TDECQ Test Filter

(in support of comment 51)

IEEE P802.3db 100 Gb/s, 200 Gb/s, and 400 Gb/s Short Reach Fiber Task Force
TF Interim Meeting, Jan 19, 2022

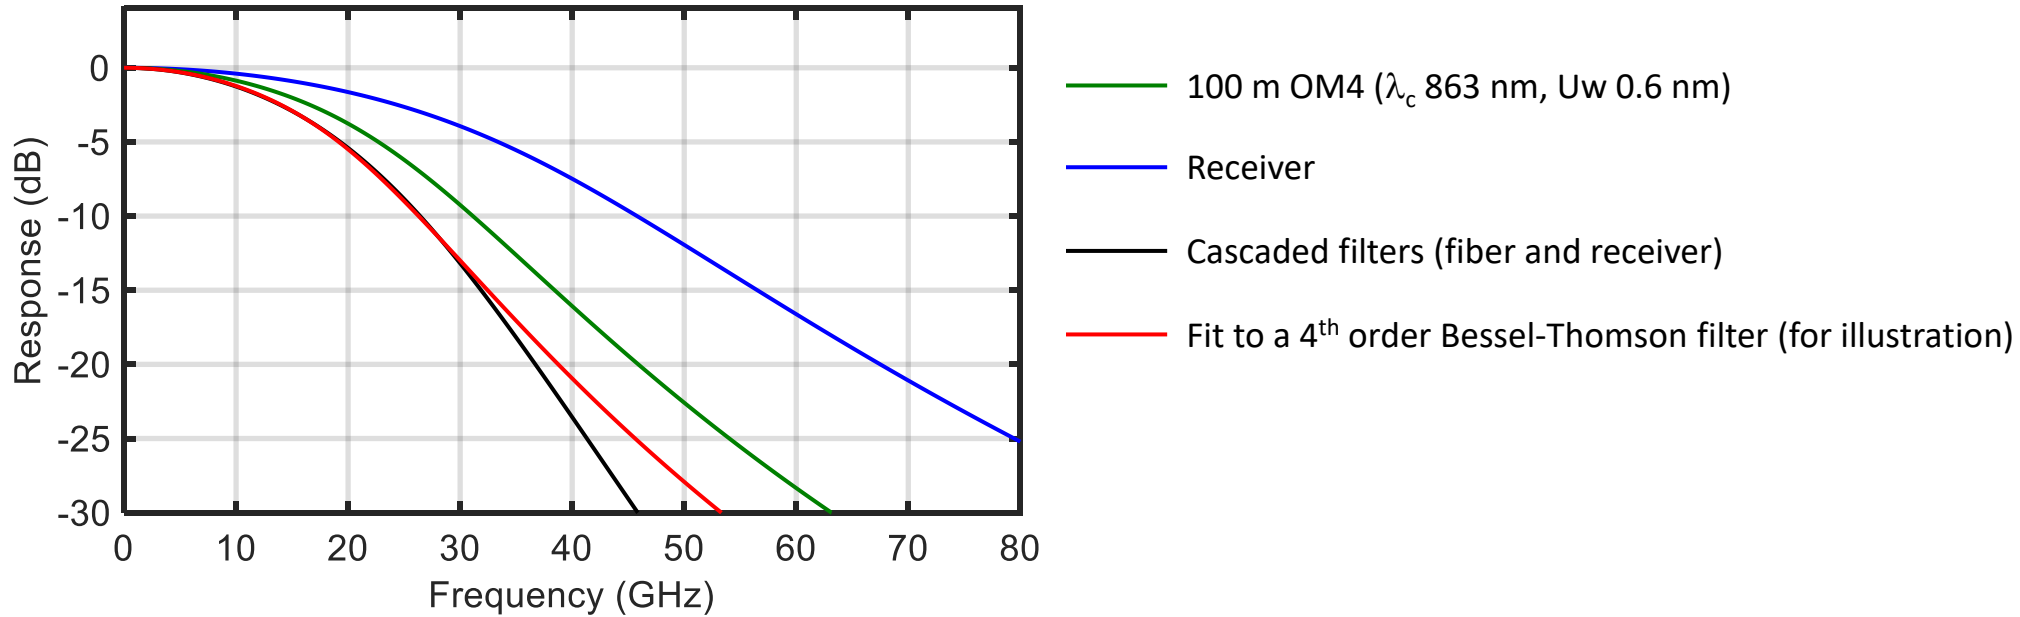
Comment #51

Roll off is defined at $2.6 \cdot f_0$, the value should be -20 dB.
